#3024705

4710 20th Ave NE **RECOMMENDATION MEETING**

4710 20TH AVE NE
SDCI# 3024705

ENTRY PERSPECTIVE

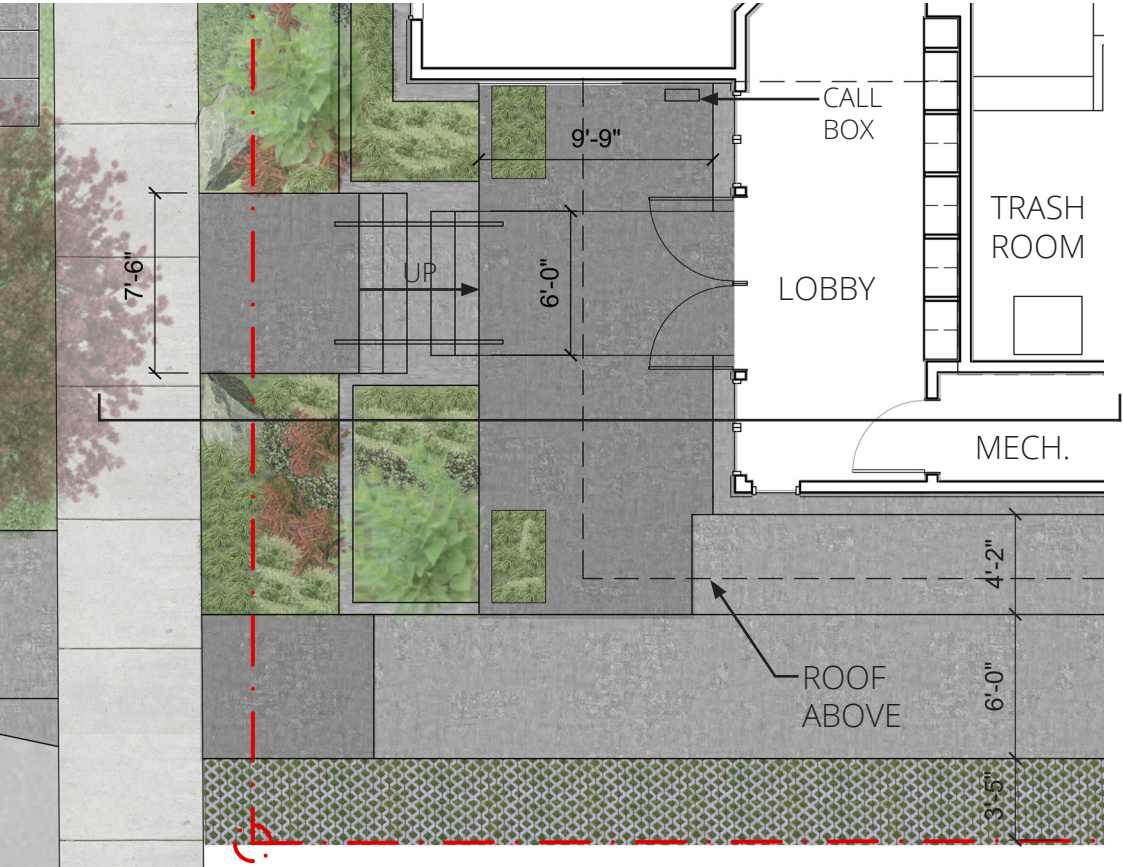
BOARD FEEDBACK/GUIDANCE	APPLICANT RESPONSE
<div><div>1ARCHITECTURAL CONTEXT & MASSING</div><div><div>1A</div><div>Neighborhood context has strong, historical architectural character associated with the University of Washington and Greek housing. (CS2-A, CS3-A, CS3-B-1, CS3-I-i, CS-3-I-iii)</div></div><div><div>1B</div><div>The proposed generous setbacks reinforce the Board’s support of Option C. (CS2-C-2, CS2-D-1)</div></div><div><div>1C</div><div>The Board supports the entry location which should emphasize the entry with bold landscaping. (CS2-B-2, PL3-A-4, PL3-I-ii, DC4-D-1)</div></div><div><div>1D</div><div>Explore pedestrian circulation, including resident circulation paths. (DC1-C-4)</div></div></div>	<div><div>1ARCHITECTURAL CONTEXT & MASSING</div><div><div>1A</div><div>The proposed project has a clearly defined, raised and recessed entry lobby similar to archetypes established by historic Greek housing and historic single family homes. Brick veneer has been selected for the primary street façade to acknowledge the neighborhood institutional context.</div></div><div><div>1B</div><div>The setbacks proposed in Option C at the EDG have been maintained. The setbacks clearly delineate a strong street façade, the recessed entry point, and fit within the developing neighborhood context.</div></div><div><div>1C</div><div>Rich and varied planting buffer the entire street façade culminating in boldly contrasting shapes, color, and texture at the entry.</div></div><div><div>1D</div><div>The primary and secondary residential circulation paths use attractive, resilient materials, and are softened by generous plantings. The trash room entry point is made secondary by facing the side yard.</div></div></div>

- 1A** The raised and recessed entry follows the established neighborhood entry archetype. The centered doors and large vertical windows clearly indicate the main entry.
- 1C** Bold planting with a variety of color and texture accentuate the importance of the entry. Golden spirit smoke trees frame the entry.
- 1D** Resident circulation paths are highlighted with plantings and site lighting. Additionally, durable quality materials are selected along circulation paths. The service exit/entry for the trash room is deemphasized by facing the side yard and by painting the door and door frame to match the color of the entry volume
- 2A** In anticipation of the wear and tear of university housing, both the street facing façade and circulation paths use brick veneer, concrete surfaces, concrete curbs, and steel guardrails to provide ease maintenance and improve durability.

- 2B** The entry volume is composed of similar and unique materials from the two larger masses. Complimentary paint and window colors relate to the brick mass, while the exterior wood soffit and railing cap provide an distinguishing accent material.
- 3D** Accent lighting within the steps and access ramp provide visual cues for points of access while exterior soffit lighting and an interior lobby up lighting create a welcoming and lantern effect.

I PROPOSED TRASH ROOM AND RAMP ACCESS

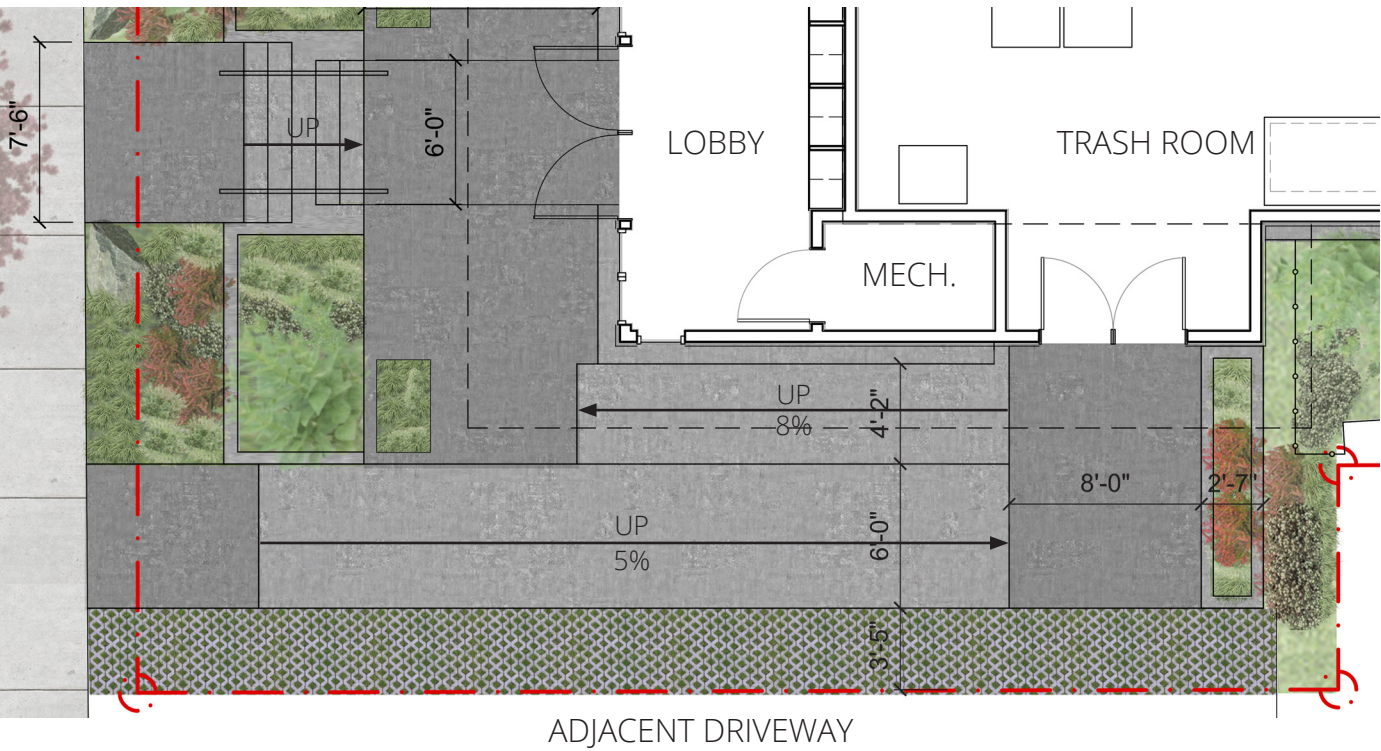
<div><div>4TRASH & ADA RAMP</div><div><div>4A</div><div>The Board expressed concern about shared use of the ramp for ADA access and trash. (PL2-A)</div></div><div><div>4B</div><div>Visually soften ADA ramp with landscaping and/or secondary architectural features along the south property line and access easement making a welcoming experience for all users. (CS2-D-5, DC4-D-1)</div></div><div><div>4C</div><div>Board had concern about the cleanliness near the trash room, but acknowledged trash room adjacency to high traffic area promotes cleanliness. (DC1-A-1)</div></div><div><div>4D</div><div>Provide trash room/ADA ramp location study. (PL2-A, DC1-B-1, CS2-D-5)</div></div></div>	<div><div>4TRASH & ADA RAMP</div><div><div>4A</div><div>The access ramp is part of the overall entry sequence and is oriented with a direct approach from the primary street façade.</div></div><div><div>4B</div><div>Thoughtful and consistent plant selection is provided at each component of the entry sequence. Secondary elements such as the guardrail have consistent detailing throughout the entry sequence.</div></div><div><div>4C</div><div>The access ramp is clearly visible from both the street and raised entry porch. The trash room access door is a tertiary component to the access ramp.</div></div><div><div>4D</div><div>Studies were made of various trash room and ramp locations.</div></div></div>

- 4A** The access ramp is part of the overall entry composition which uses consistent, quality materials along all circulation routes.
- 4B** Bold plantings are consistent along the ramp sidewalk landing, intermediate landing and the porch landing. The guardrail provides a secondary architectural detail and scale. The guardrail is composed of strong vertical elements, lighter horizontal elements, and a wood railing cap which compliments the wood entry soffit. Stained concrete landings highlight ramp transitions and mirror the stair path.
- 4C** The access ramp is clearly visible from a pedestrian or vehicular approach, and is completely visible from the raised porch. Both residents and neighbors have eyes on the ramp.

1 ENLARGED COMPOSITE PLAN OF REAR YARD
N.T.S

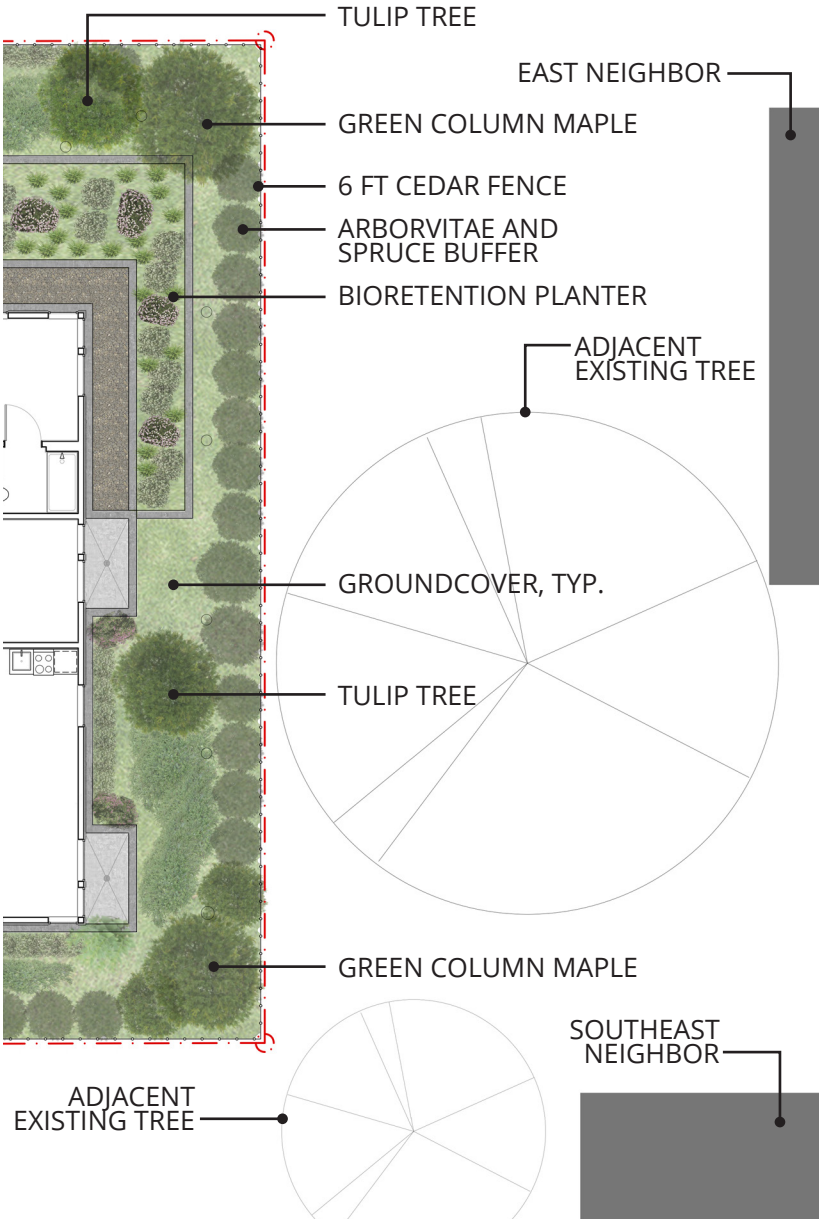
<div><div>3LANDSCAPING, SAFETY & SECURITY</div><div><div>3A</div><div>Board supported proposed landscape vegetated screening/buffer along east property line. Keep landscaping low to discourage trash dumping and enhance security. Provide large tree at NE corner of site to balance neighboring tree to east. (CS1-D-2, DC4-D)</div></div><div><div>3B</div><div>Provide gated fencing along north property line to enhance security safety for residents, especially basement units. (PL2-B, PL3-A-1, PL3-A-2, DC4-I-v, DC4-D)</div></div><div><div>3C</div><div>Enhance basement units access to light and air with terracing and/or increased size. (CS1-B)</div></div><div><div>3D</div><div>Provide a site lighting plan to address safety and security needs. (PL2-B-2, DC4-C-1, DC4-I-vii)</div></div></div>	<div><div>3LANDSCAPING, SAFETY & SECURITY</div><div><div>3A</div><div>Thoughtful, appropriately tall planting is provided along the east and south-east property line. A large caliper tree is located at the NE corner of the site.</div></div><div><div>3B</div><div>A gated fence is provided around the property. The fence is offset from the street facing building façade at the secondary residential entry.</div></div><div><div>3C</div><div>The width and length of windows wells was increased to improve access to light and air. Guardrails are provided where circulation paths are adjacent.</div></div><div><div>3D</div><div>Lighting is used to make residential circulation paths secure, highlight the entry sequence, and enhance the landscape.</div></div></div>

- 3B** The 6 foot tall cedar fence and gate establishes a secure boundary around the site perimeter while maintaining visual connection through regular breaks within the siding. The fence also provides a visual buffer from the adjacent driveway to the north.
- 3C** The window well size has increased to a 7'-0" x 3'-6" clear inside dimension. The 42" tall steel guardrails at the north window wells improve safety and security. Minimal horizontal and vertical members sizes were used to maintain access to light and air.
- 3D** Pathway lights are located along the walkway, with concentrated lighting at the access gate. Integral step lighting provides a clear and safe path of travel. Additionally, each window well has a tenant operated integral light.

3A Selected plantings along the east perimeter provide a visual buffer to adjacent neighbors. Both selected plants, Emerald Green Arborvitae and Weeping White Spruce, provide dense foliage. A large caliper Green Column Maple is located in the NE corner of the site to balance with the large established tree east of the property.

3B A 6 foot tall cedar fence encloses the entirety of the back yard and side yards.
